# Fiat Fashion Ltd

07 November 2013

# Building Observations

# Check required on column design

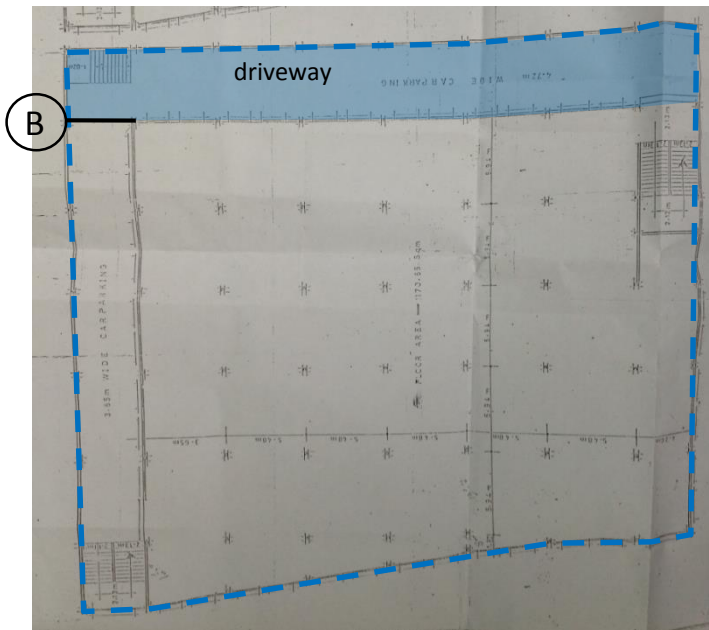
Cursory calculations indicate column working stress is at high level for edge columns and along Grid B

Engineer is to perform detailed calculations and concrete tests to prove column size and (if required) :

- Reduce loads by vacating floors
- Reinforce columns

Testing carried out.  
Column material is found to be brick chip aggregate

# As built drawings

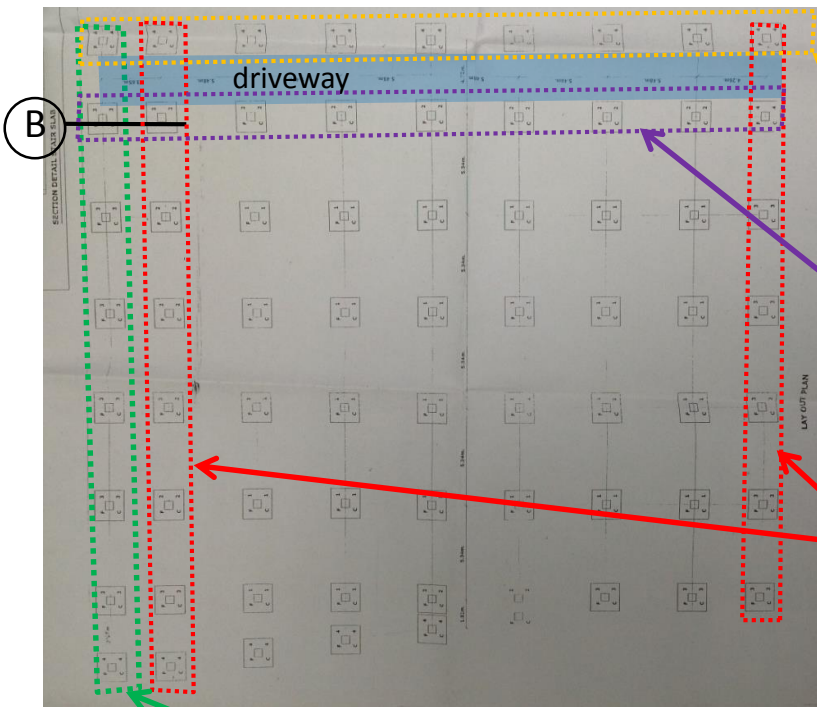
**Edge Columns**  
 Per drawing: 356mm x 430mm (14"x17")  
 Measured on site: 250mm x 370mm

**Grid B Columns**  
 Per drawing: 457mm x 457mm (18"x 18")  
 Measured on site: 380mm x 300mm

**Edge columns support a 2m cantilever slab, which is not represented on the drawings**

**This column line does not exist**

**Current structural drawings do not match the as built conditions – accurate as built drawings are required**

**As built drawings**

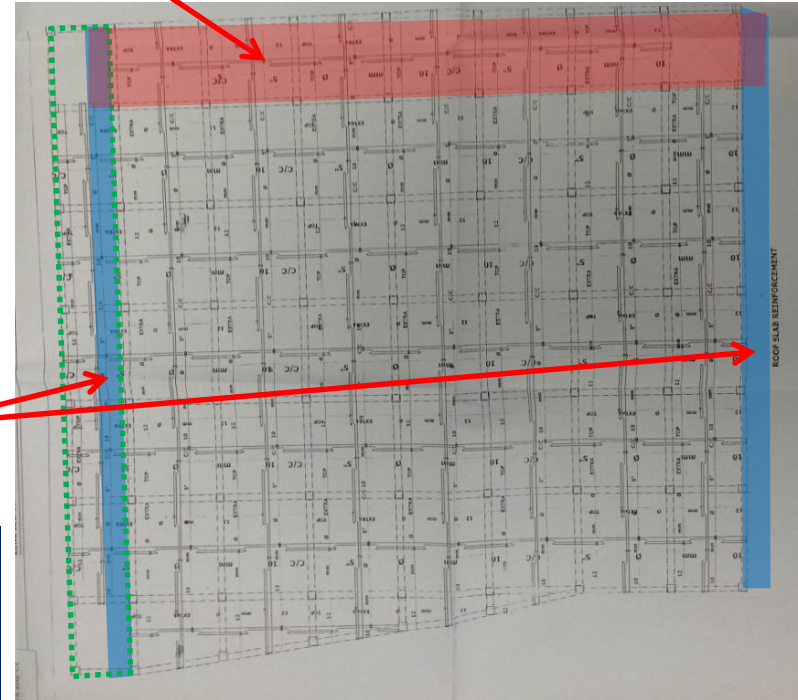
No downstand beams in this area. This is not reflected on the drawings

2m cantilever is not shown on drawings

Current structural drawings do not match the as built conditions – accurate as built drawings are required

# Check required on slab design

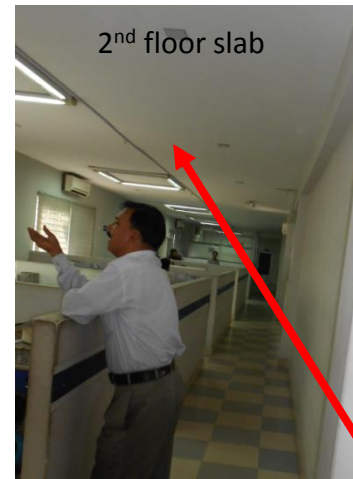
Heavy additional loads due to 500mm raised floor on 1<sup>st</sup> floor office area

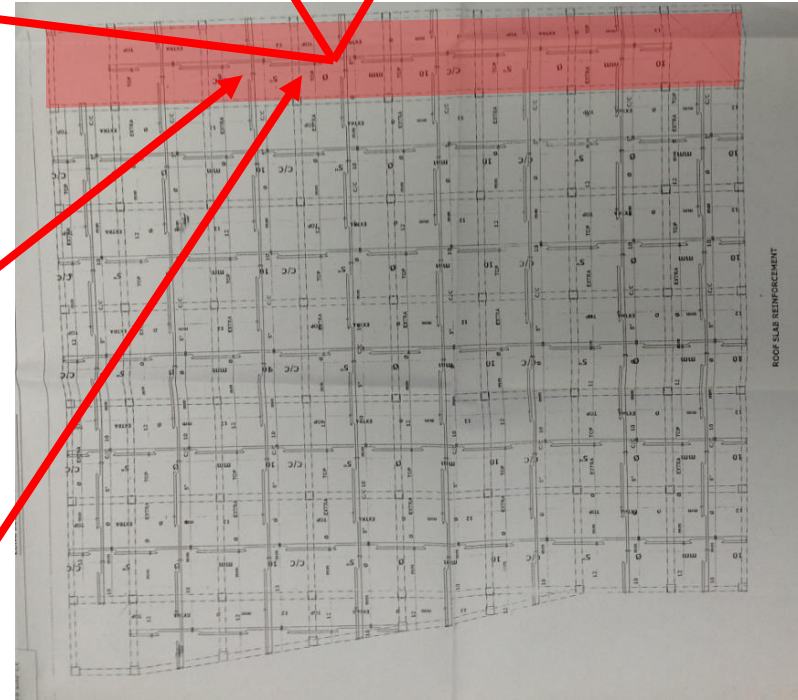
As built condition shows no beam at this location (Drawings assume beams at in all bays)

Check on slab design required

# Load Management

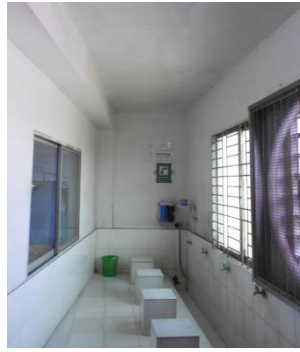
**Permanent loading due to raised floors and partition walls:**

**Factory loading on cantilevers and in storage areas:**

**Engineer to produce loading plans based on as built conditions. Load management set in place.**

# Fabric bag pile loading perimeter columns

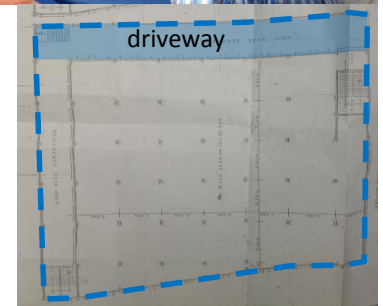
Fabric bag  
pile loading  
perimeter  
columns

Do not store loads against wall  
and columns, on either side of  
the wall

# Protect columns from Vehicle Impact

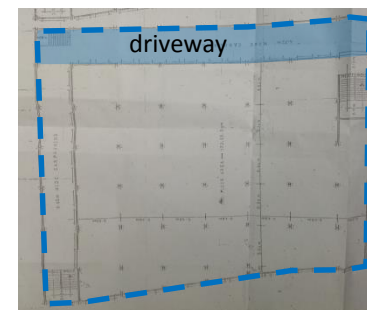
Columns on all sides of the driveway to be protected from vehicle impact
